Regeneration and Economic Development
Durham County Council
County Hall
Durham
DH1 5UL

22 May 2014

Re: Durham Bus Station relation proposals

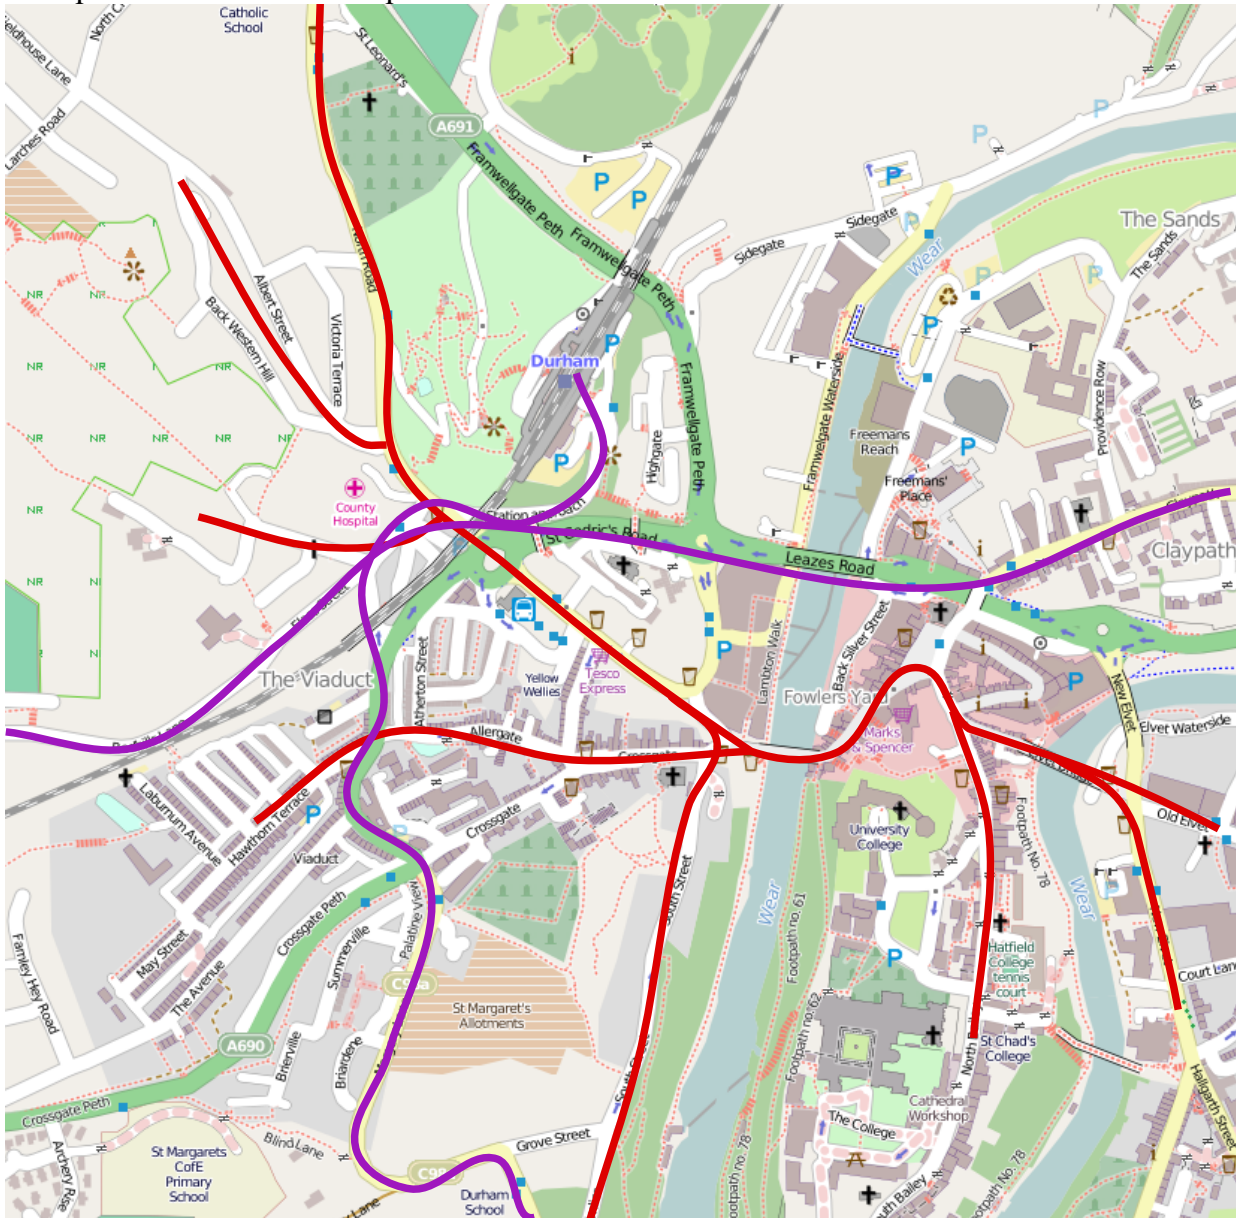
If we put these routes on a map it looks like this:

Two routes have been marked in purple. **These are the only ones at present accessible by bicycle throughout their entire length.** The purple route from left to right, while accessible, is far from satisfactory. The route from the station to the science site could also be improved.

To make the other routes marked in red available to cyclists, the following measures would be needed.

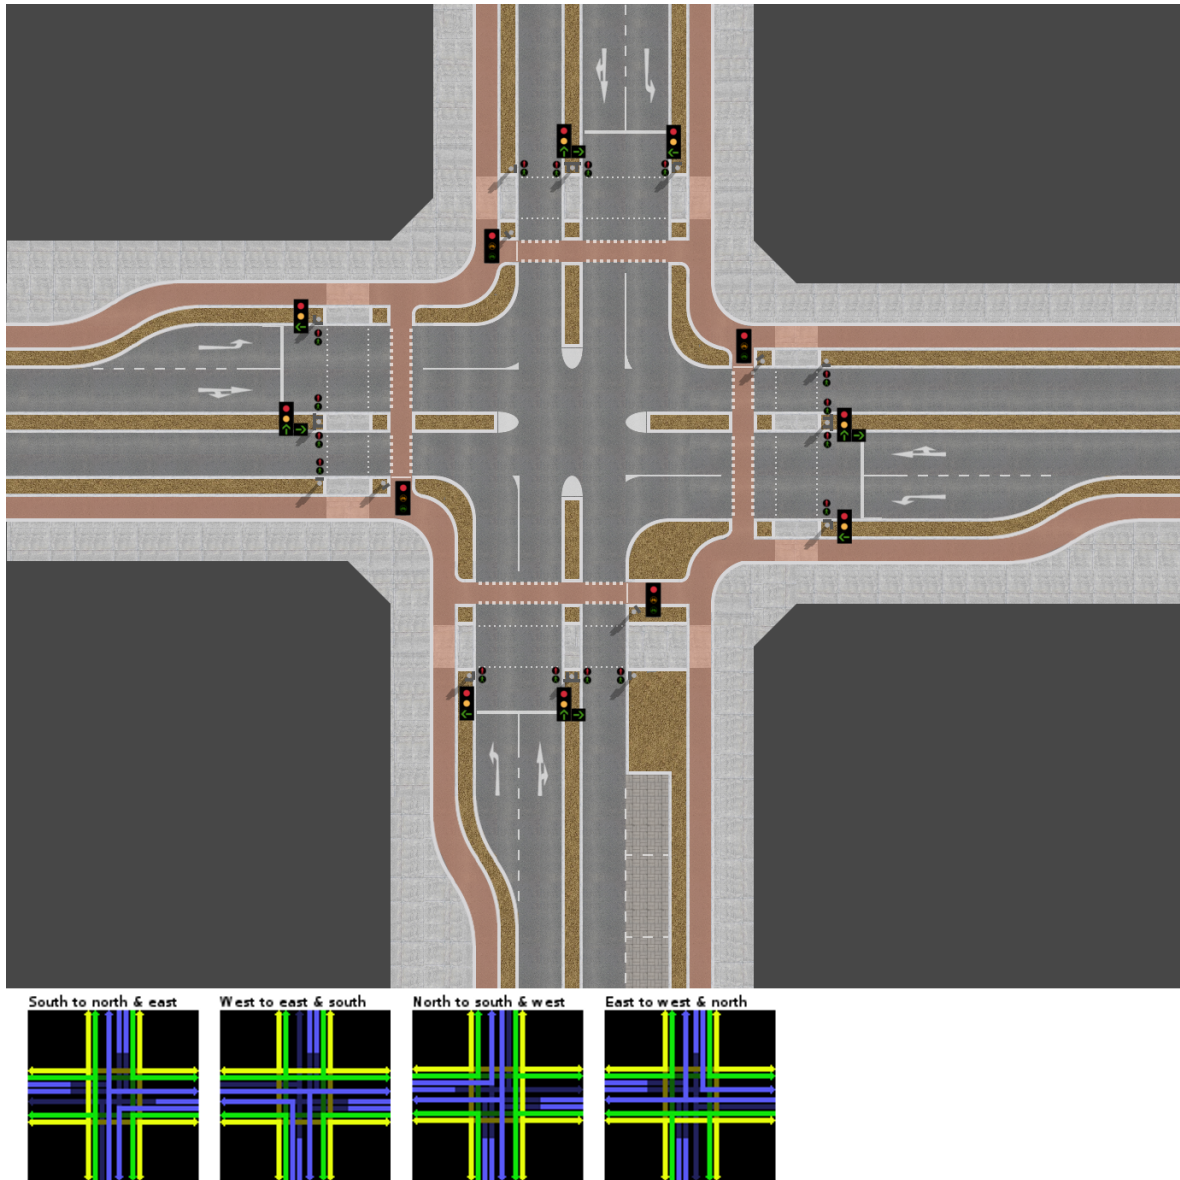
Designers should consider using innovative traffic signals such as (i) advanced green cycle signals, or (ii) simultaneous green phase for bicycles.

Without simultaneous green it is still possible to provide segregated crossings which are efficient for cyclist and motor traffic. An example cross-roads is shown below. The diagrams under the plan show how the phases are sequenced. Note that the two-stage right-turn for the cyclists is facilitated by the sequencing.
